RFT# 4239 - Addendum #2 Heat Pumps and Electrical Service Bicentennial School

To: All Bidders
Date: May 30, 2024
From: Nancy Rideout, Purchasing Manager
Office: (902) 464-2000 ext. 2222
Email: nrideout@hrce.ca

PROJECT
BICENTENNIAL SCHOOL - HEAT PUMPS AND ELECTRICAL SERVICE

- CONCRETE NOTES**
- ALL CONCRETE SHALL CONFORM TO CSA-A23.1-19 AND BE READY MIX.
 - MINIMUM COMPRESSIVE STRENGTH OF CONCRETE AT 28 DAYS SHALL BE 32MPa.

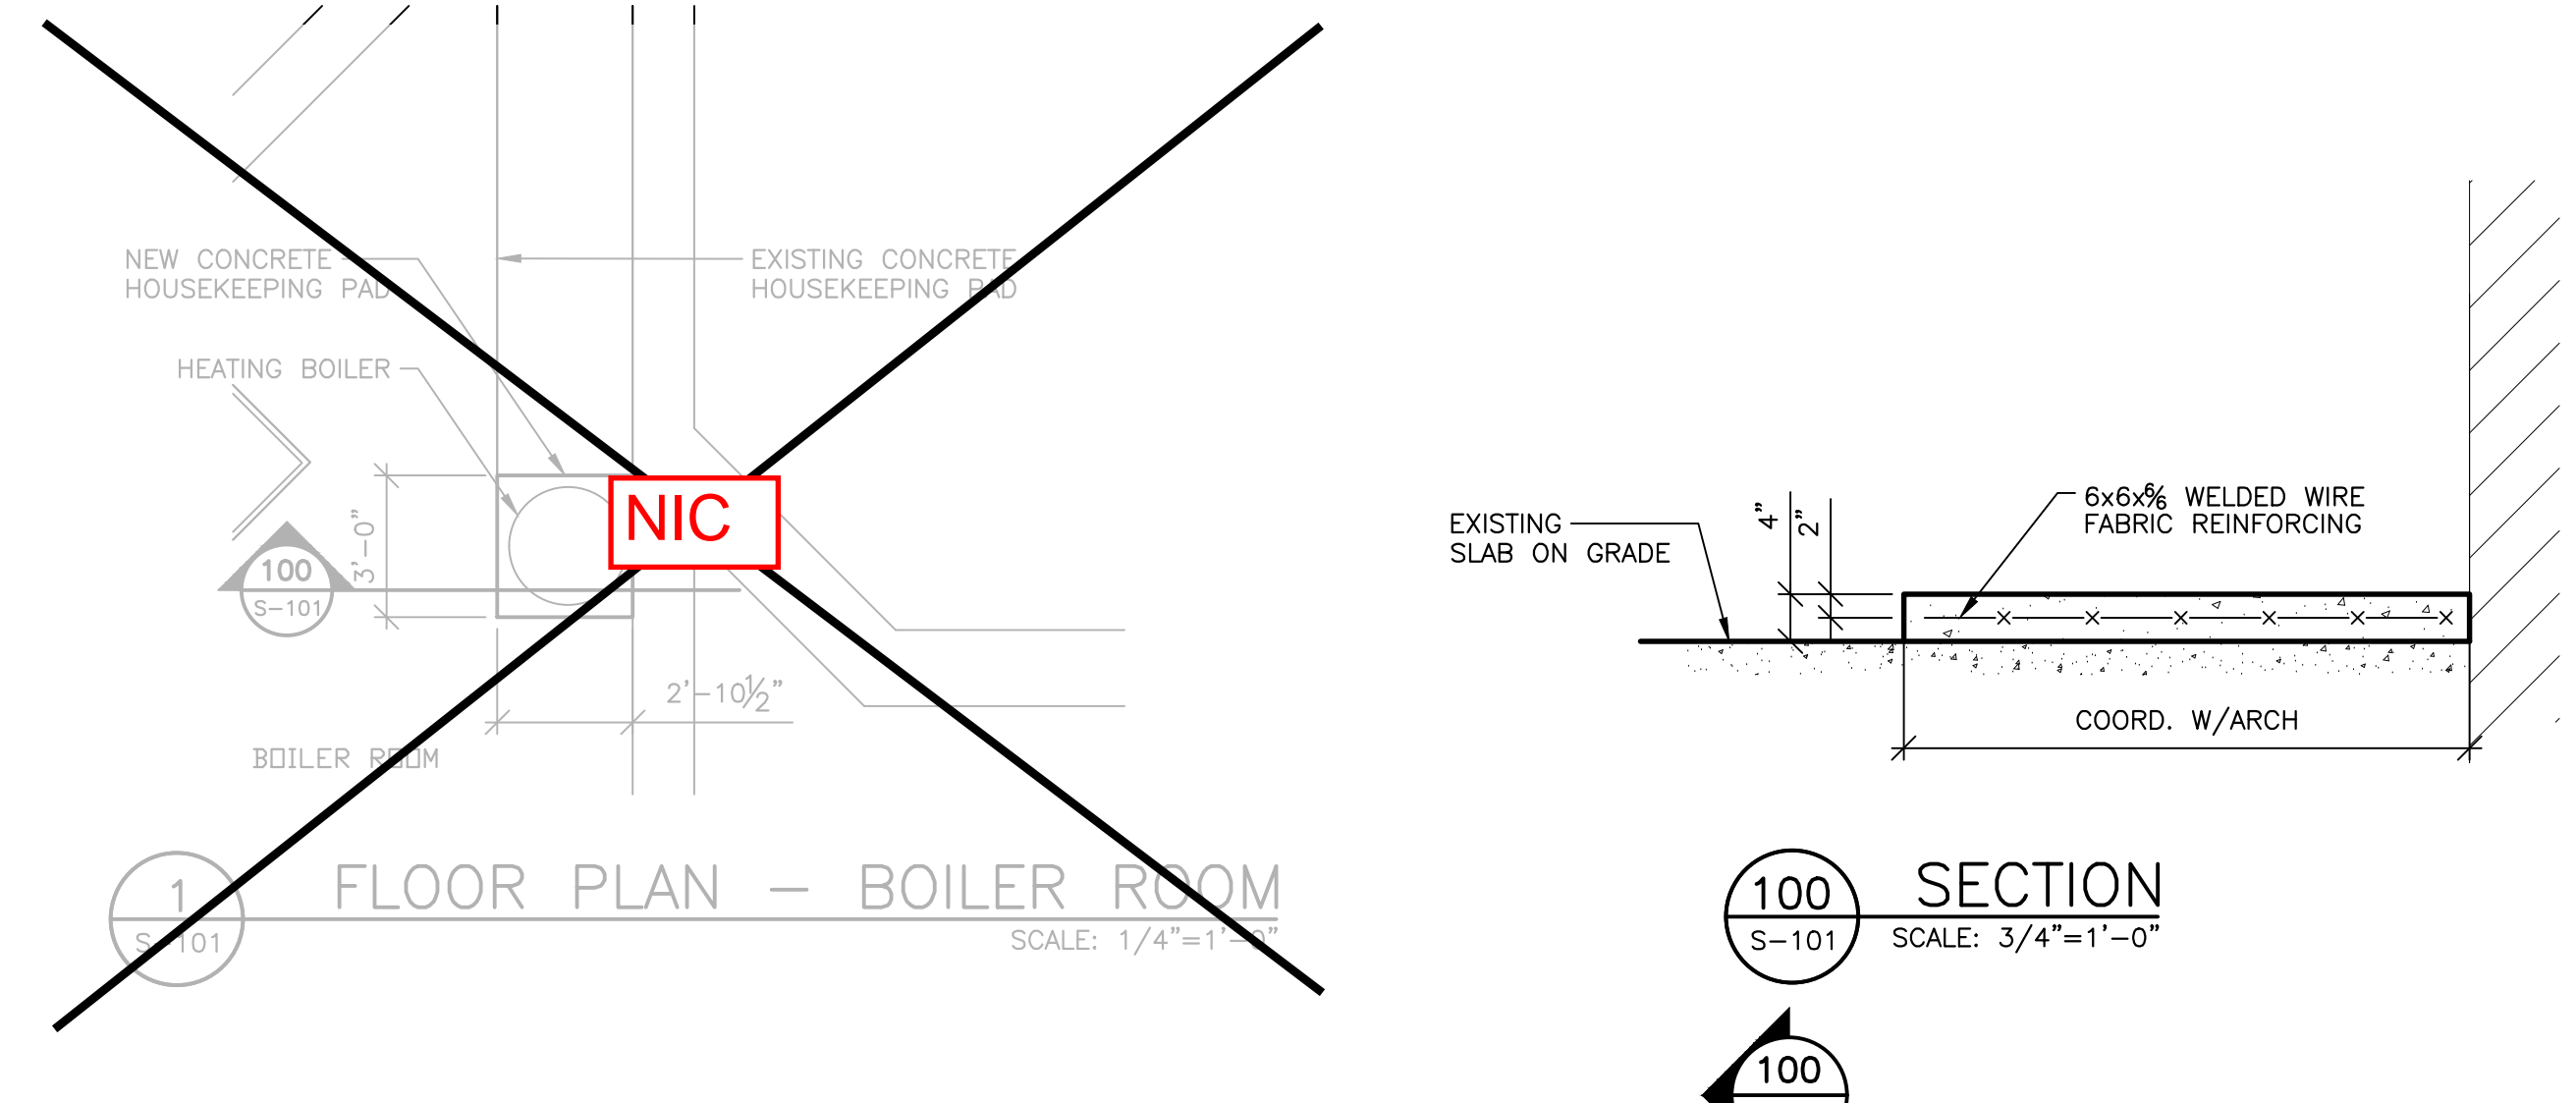
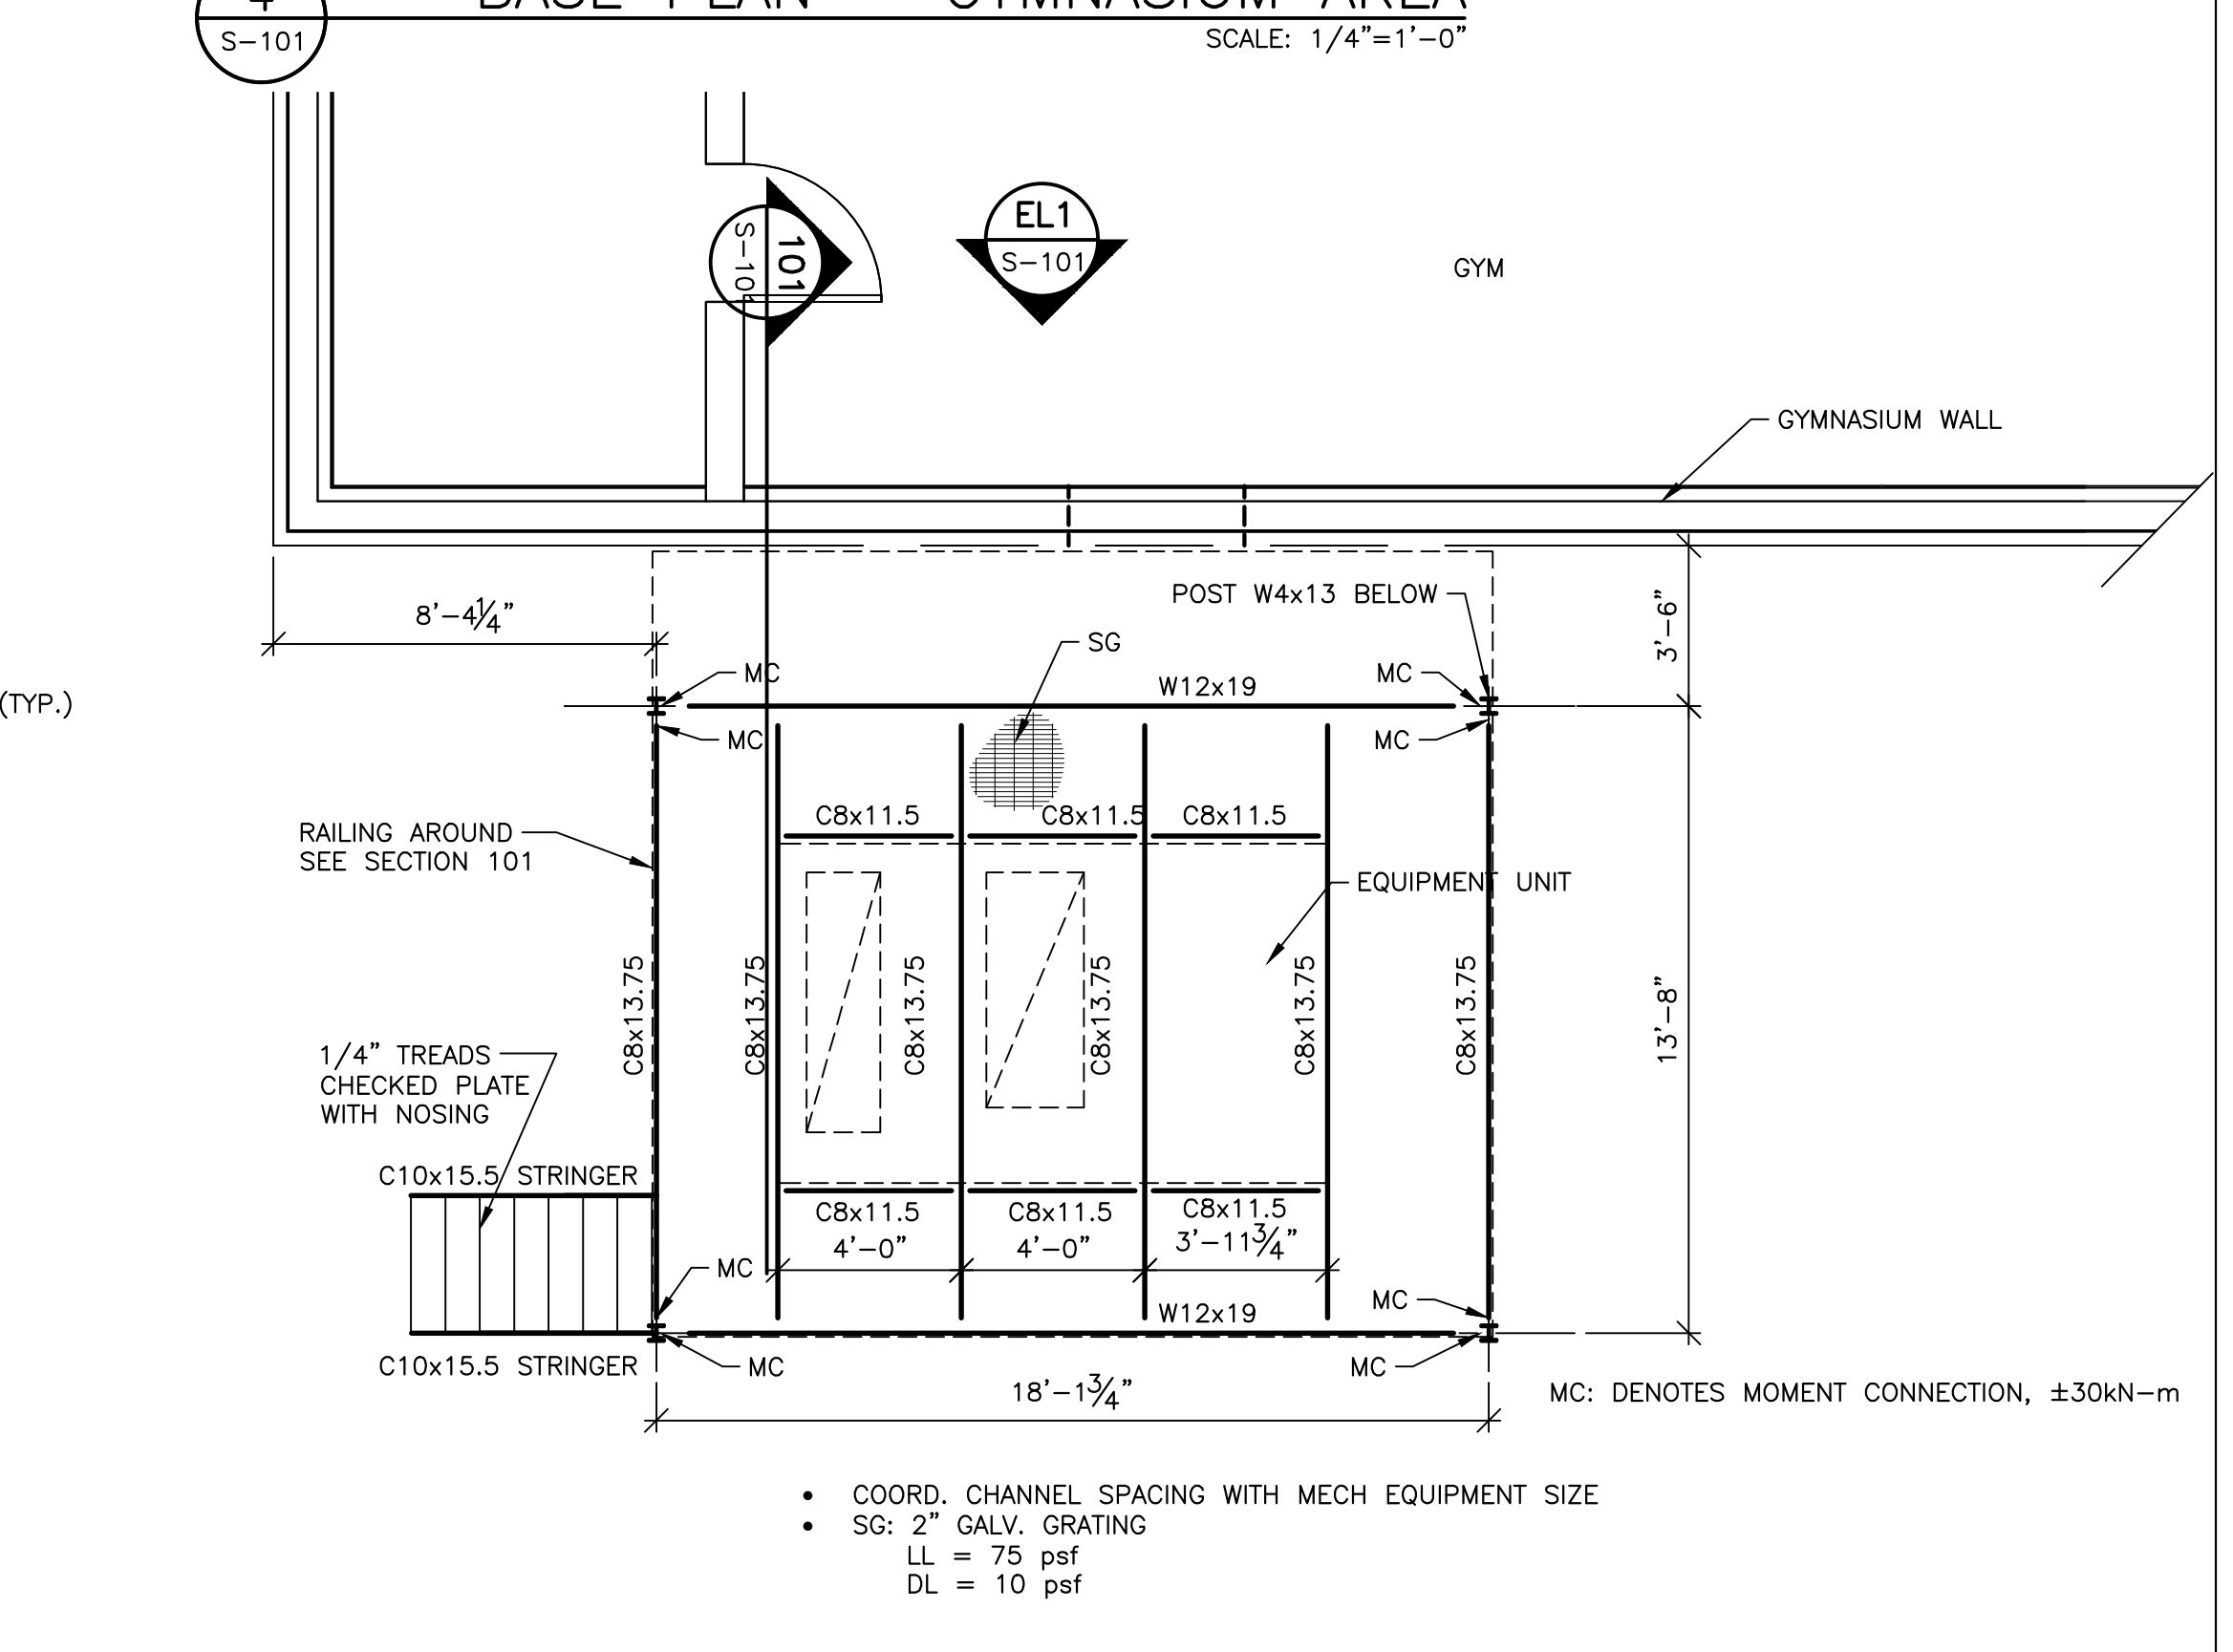
(Part 3) On drawing MV-104, there is a note regarding the structural stand for AC-1 to see structural drawings for information. Assuming the stand is part of this tender package, please provide structural drawings.

(Part 3) Structural drawings are included with this addendum. Refer to "Additional Information" at the end of Addendum #1.

- 1) Structural drawing S101.1 STRUCTURAL DETAILS – Enclosed – 24 MAY 2024
